DISCIPLINARY COMMITTEE – UPHELD COMPLAINTS LESSONS TO BE LEARNT

CASE STUDY
AUGUST 2023 – FIRE REPORT

FIRE ASSESSMENT IN ACCORDANCE WITH C/ASL (2005)

Figure 1: Original report – proposed fit out solution.

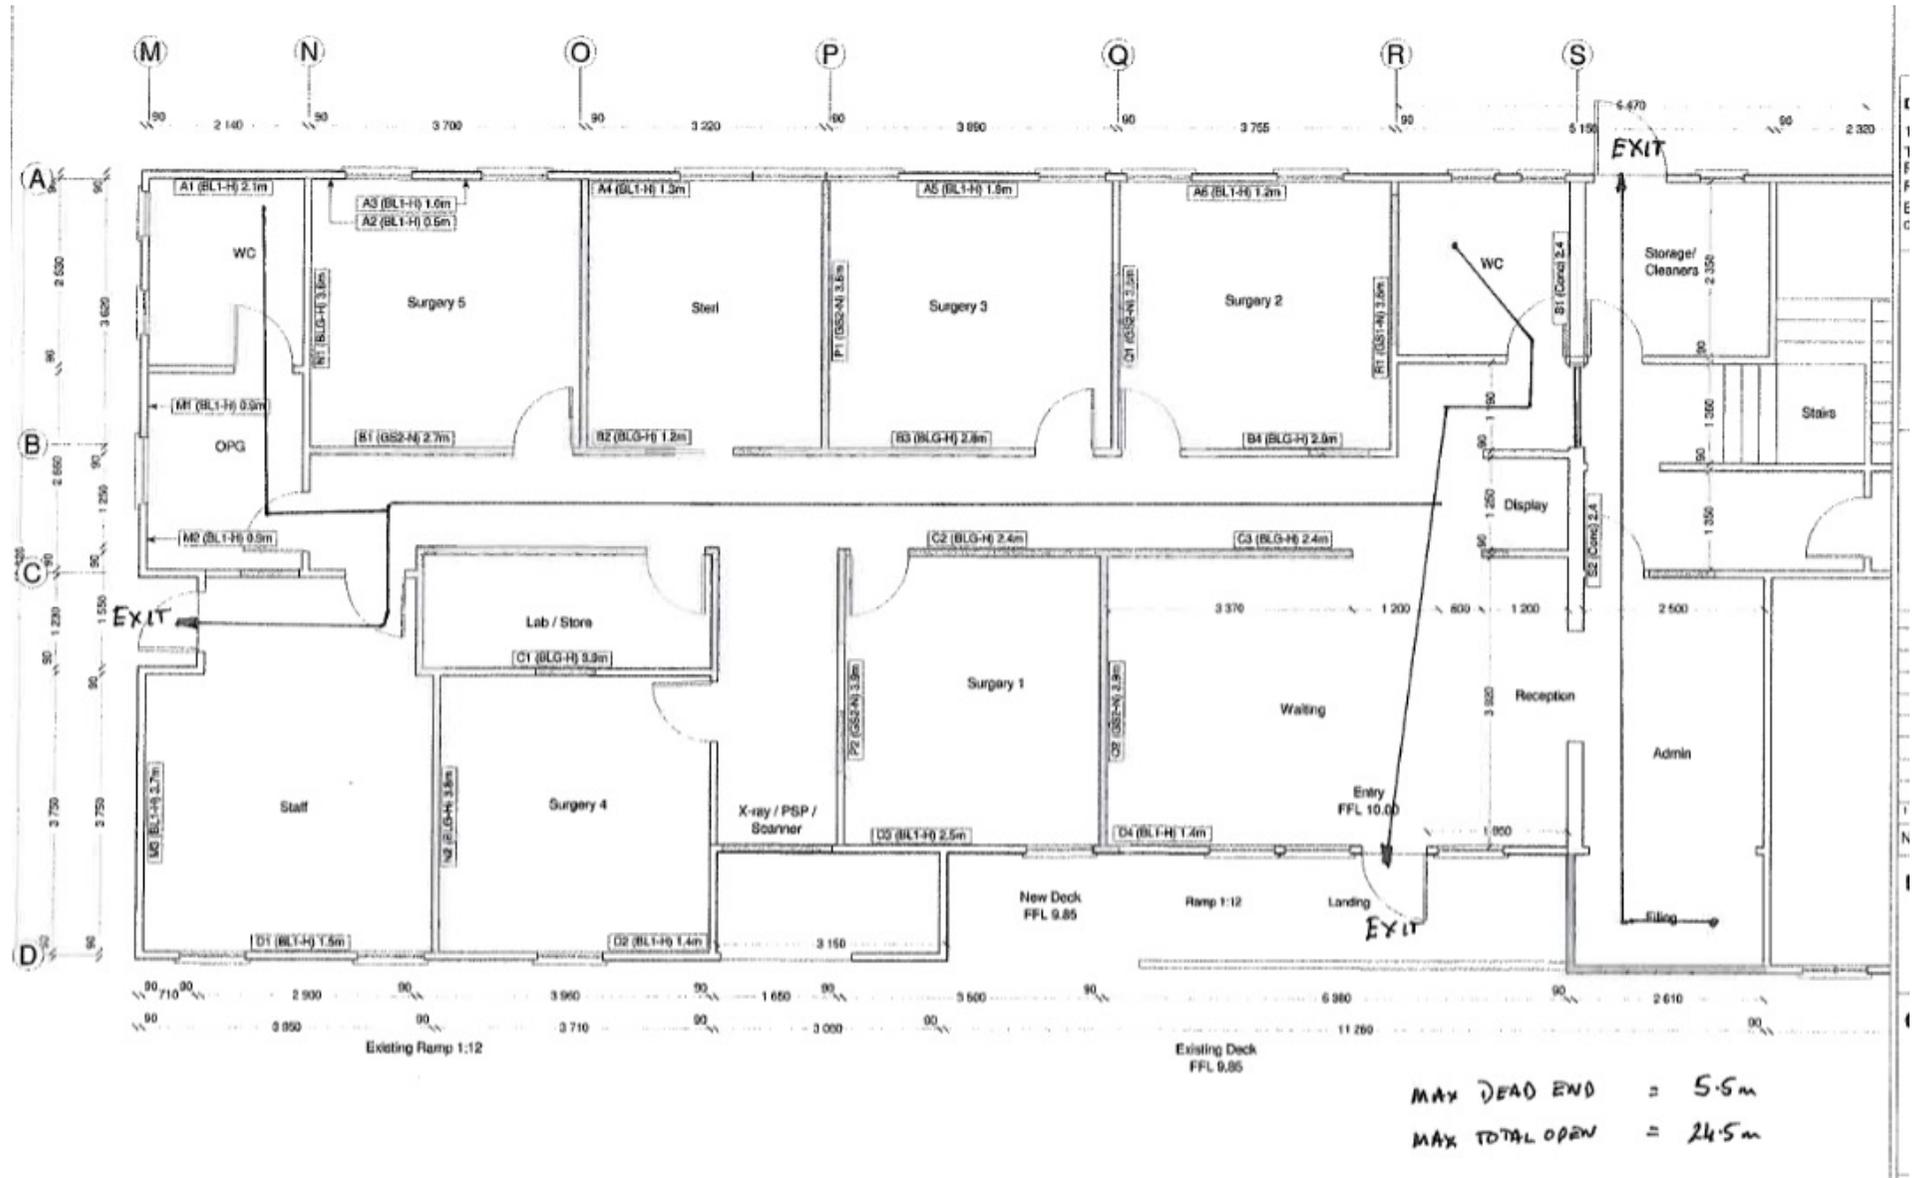
The complainant stated that "the NZFS has significant concerns with regard to this design and its potential impact on the safety to all occupants of the building". He highlighted their concerns that the compliance document C/AS1 had not been applied correctly and that there was insufficient information in the report to determine whether the design was adequate. The complainant also noted that "The fire report has neither assessed the occupancy of the rest of the building nor provided any justification for their exclusion (eg by fire separating this tenancy from the rest of the building)."

The report was slightly longer than a page and included a floor plan of the area of work and some escape route lengths. The report omitted the following.

1. The work being undertaken was an alteration to a building and that Section 112 of the Building Act applied.
2. Assessment of means of escape for the rest of the building.
3. The current version of the Acceptable Solution to use was Amendment 9 rather than Amendment 5 referenced in the report.
4. No discussion of fire separations, number of floor levels or population in each firecell.
5. No justification for the required fire safety precautions.

Section 112 of the Building Act requires that ‘the building’ complies with the provisions of the building code for means of escape from fire, as nearly as is reasonably practicable, and continue to comply with other provisions of the building code to at least the same extent as before the alteration. Section 112 does not limit the scope of assessment to just the area of work but addresses the entire building.

Apart from a simple “statement of change”, the more rigorous assessments require an understanding of the current state of the building to be able to compare how the building is currently constructed and used with what would be required if it were a new building. Most of this information can be found on existing plans and fire reports, however the state and use of a building can change over time. It is good practice to carry out a building inspection to ensure that the layout is as per the known plans, that the fire safety systems are as stated in previous fire reports and that fire separations are in the correct locations, fire doors are in operation and any easily visible passive fire is compliant. If the fire report author had undertaken a site visit, they would have determined that one of the fire exits was no longer available. This is a fundamental feature of the egress design.

By following the documentation guidelines in Practice Note 22 and carrying out a site visit the fire report author would have been in a much better position to demonstrate to the BCA how the alteration would comply with Section 112 of the Building Act. For current fire report authors carrying out Section 112 assessments, the MBIE guidance is also an invaluable tool for determining the level of rigor that needs to be applied to an assessment.

1. Verify the current state of the building by
 - a. review previous consents (council property file)
 - b. conduct a site visit
2. Use the MBIE guidelines for “Requesting information about means of escape from fire for existing buildings” and attach the score sheet to the fire report
3. Have a fire report template(s) with all the necessary headings pre-prepared to complete
4. Check the MBIE website for the latest compliance documents which are free to download.
